Fire Pump Annual Test — Independent Analysis

Riverview Medical Plaza · FP-1, Pump Room B1 (model/serial/driver model/controller not specified) · Analysis date: 2026-10-27

PRE-SUBMISSION CHECK — CONTRACTOR

CORRECTED PERFORMANCE VS. RATED

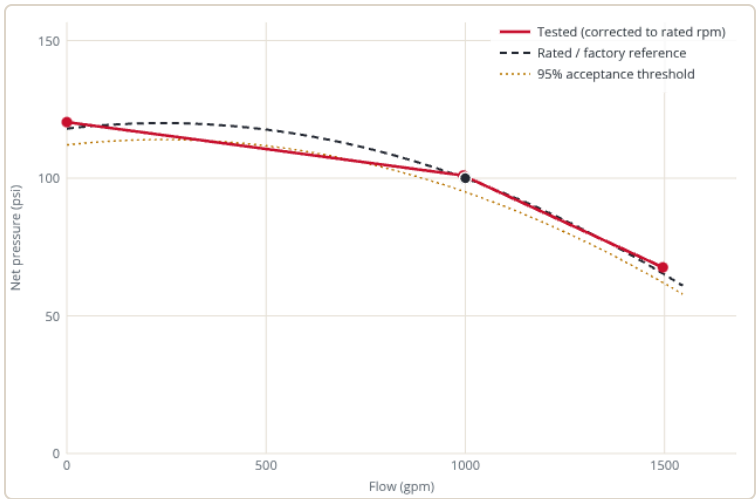
100.6%

of rated
pressure at
100% rated
flow ($\geq 95\%$)

104%

of required
pressure at
150% overload

120%

churn as % of
rated (limit
140%)

MULTI-YEAR TREND — NET PRESSURE AT RATED FLOW

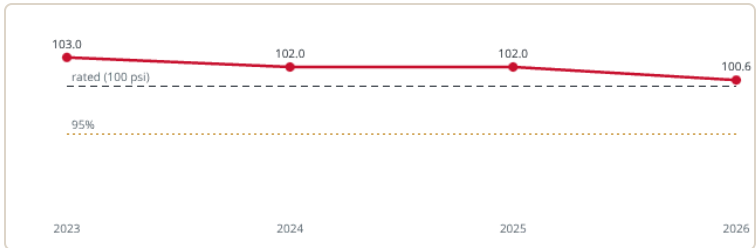
NOTE Mild decline of 2.3% at rated flow since 2023 — within normal wear; continue monitoring annually.
